# PHY Link Frame adjustments

to align with US Superframe

Duane Remein; Huawei

Avi Kliger; Broadcom

# Proposed Downstream Frame

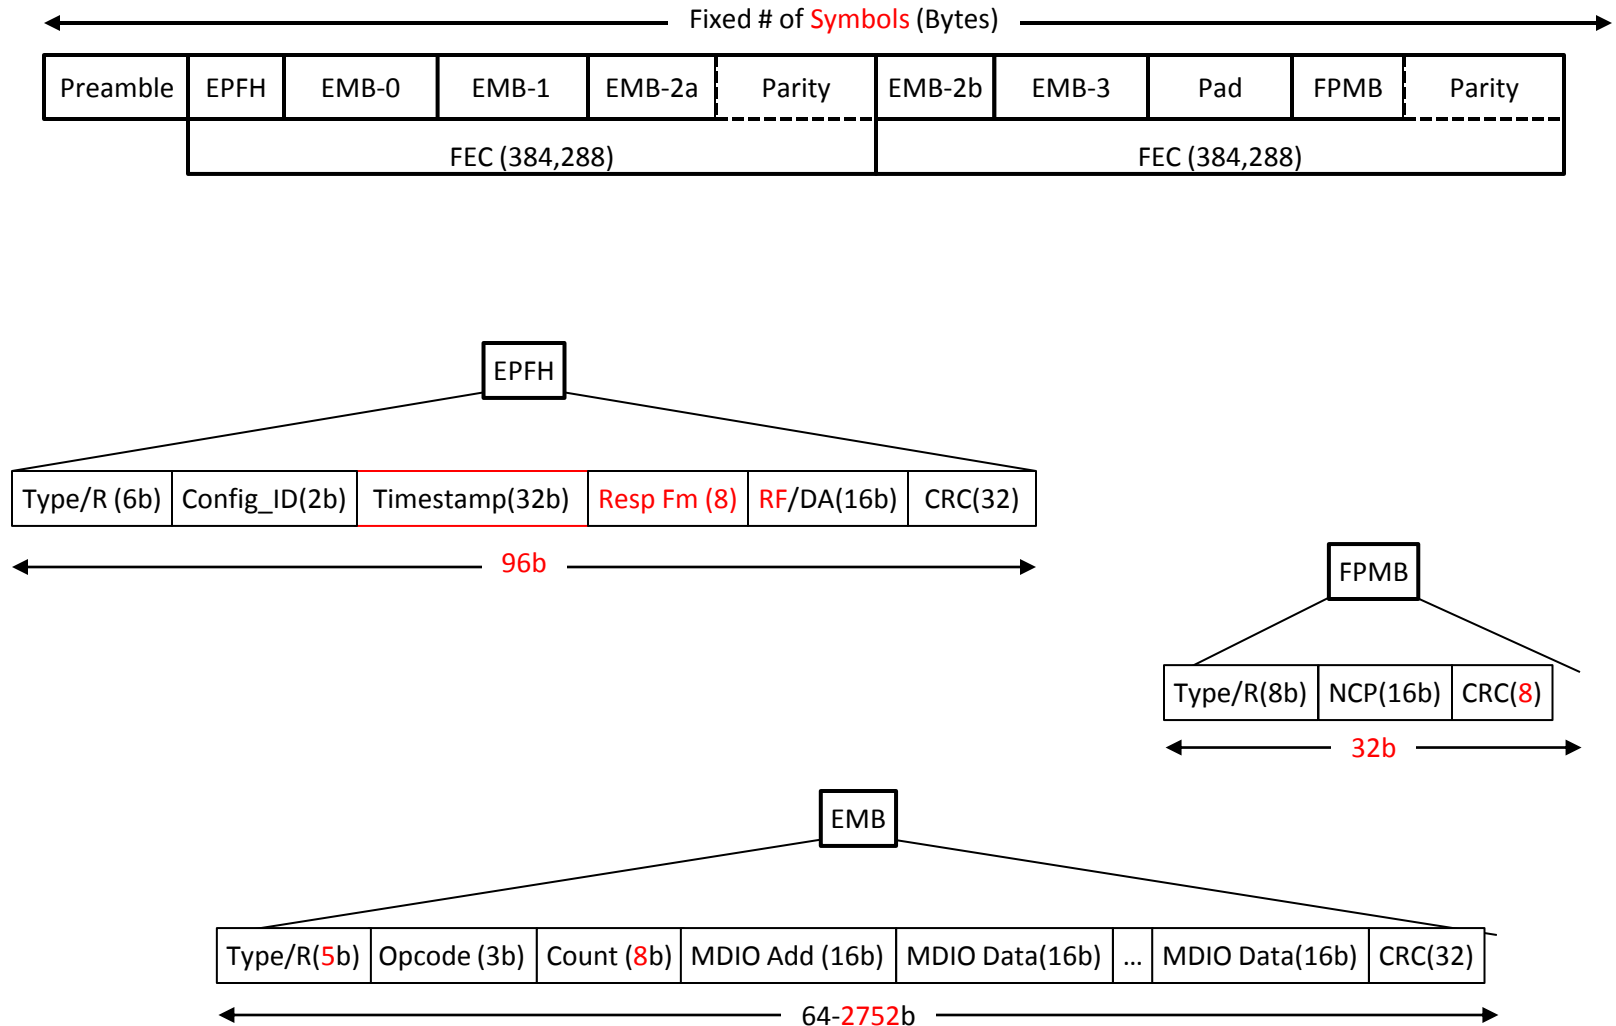
# Current Downstream Frame

# Proposed Upstream Frame

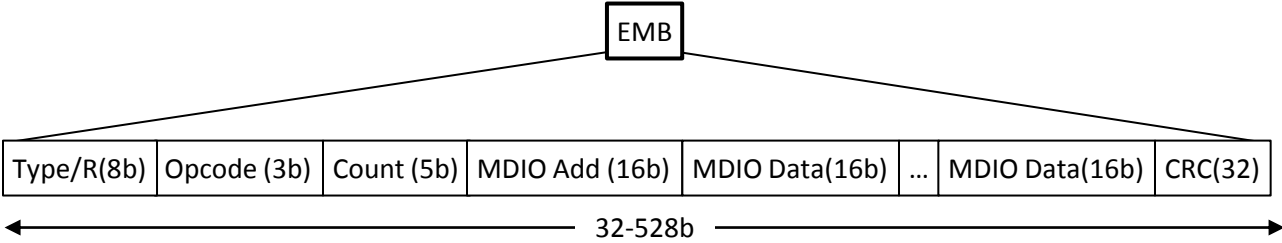
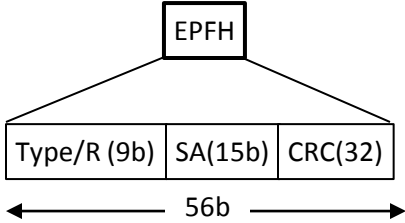
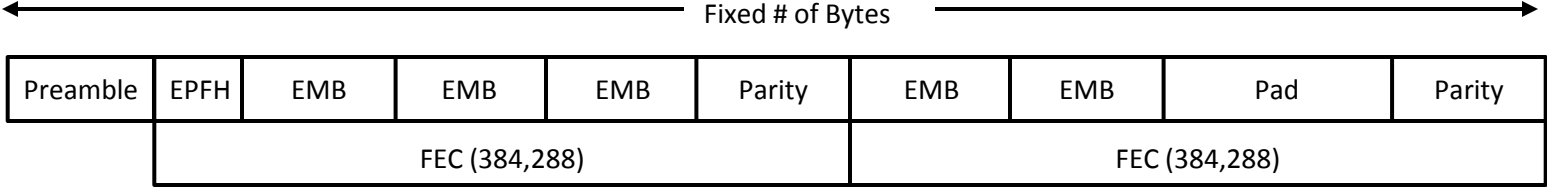
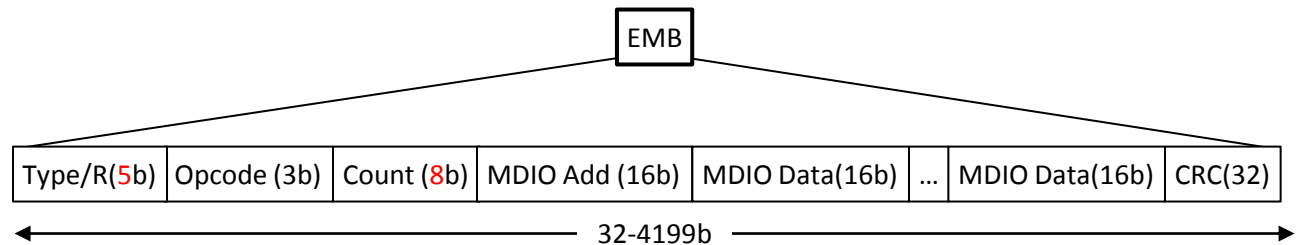
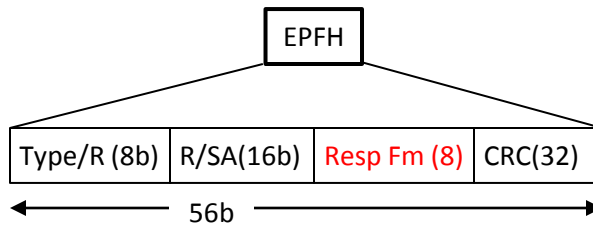
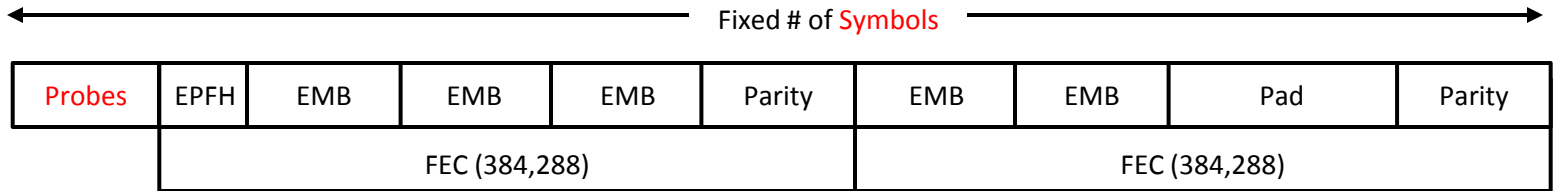
# Current Upstream Frame

Revised Figure 102-3—PHY Instruction response

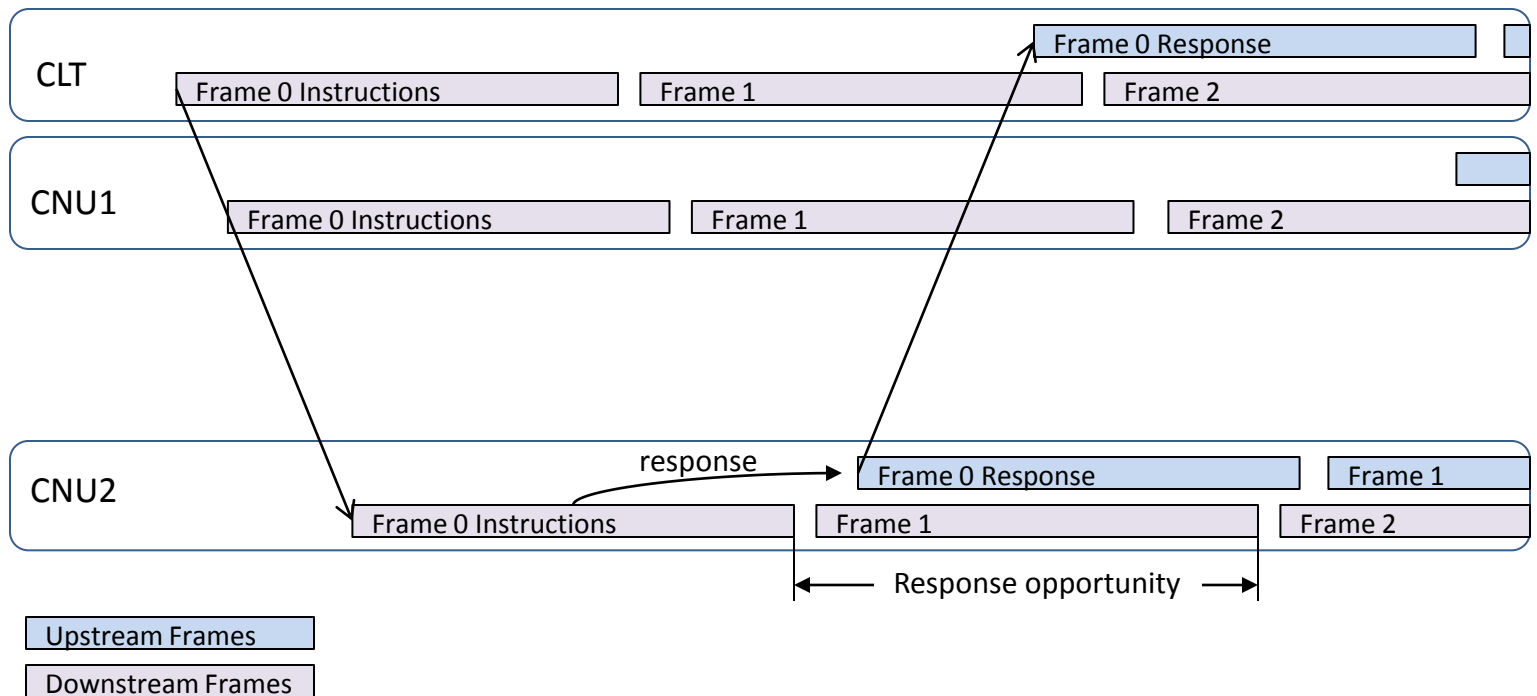
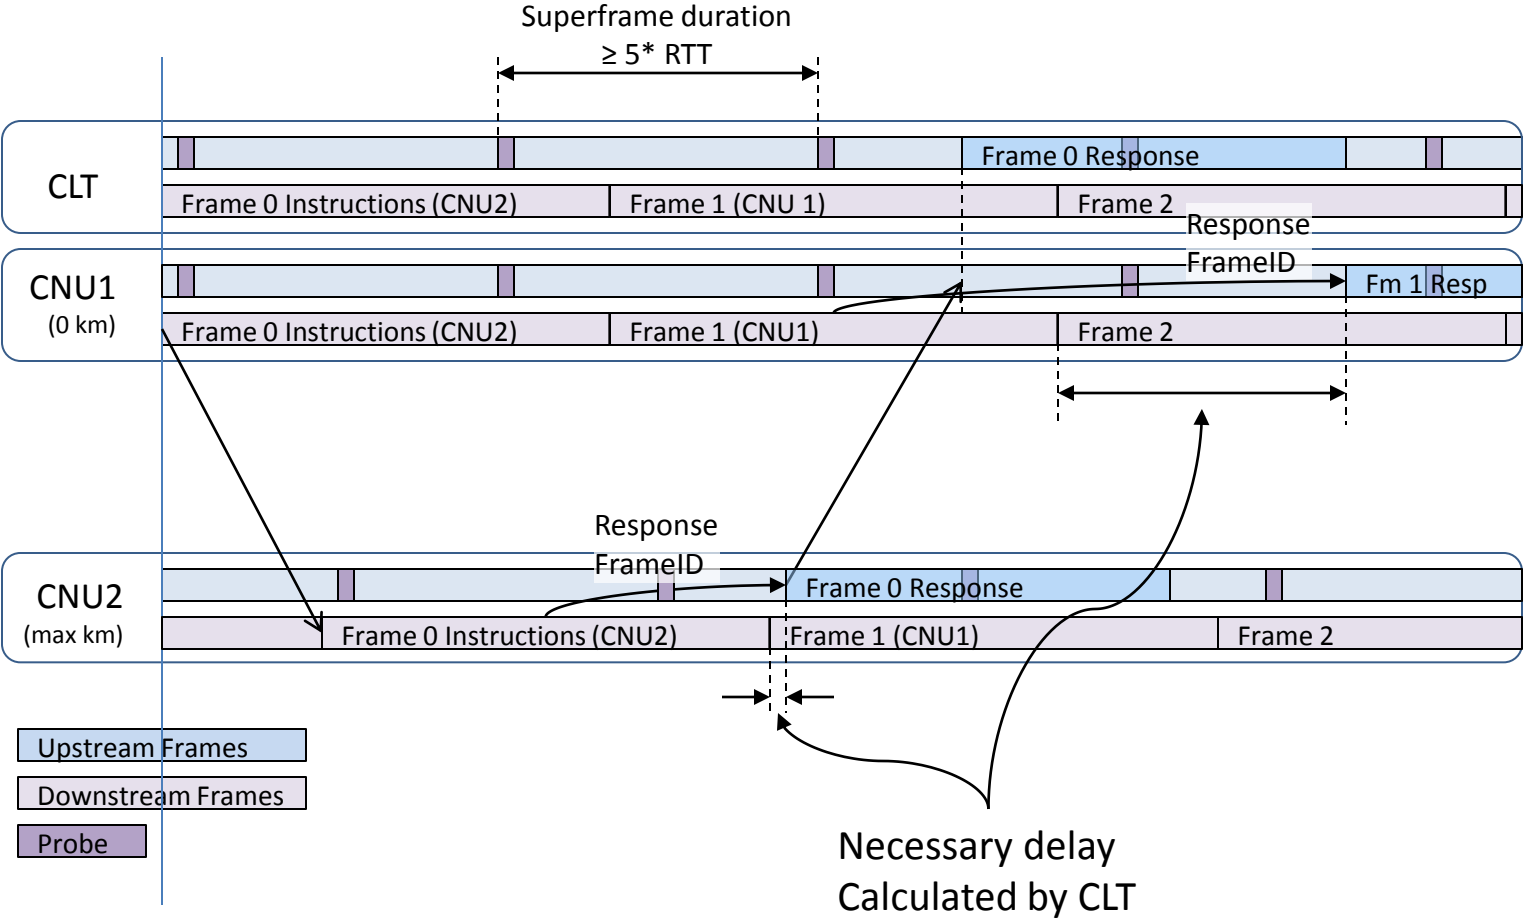
# Proposed PHY Instruction response
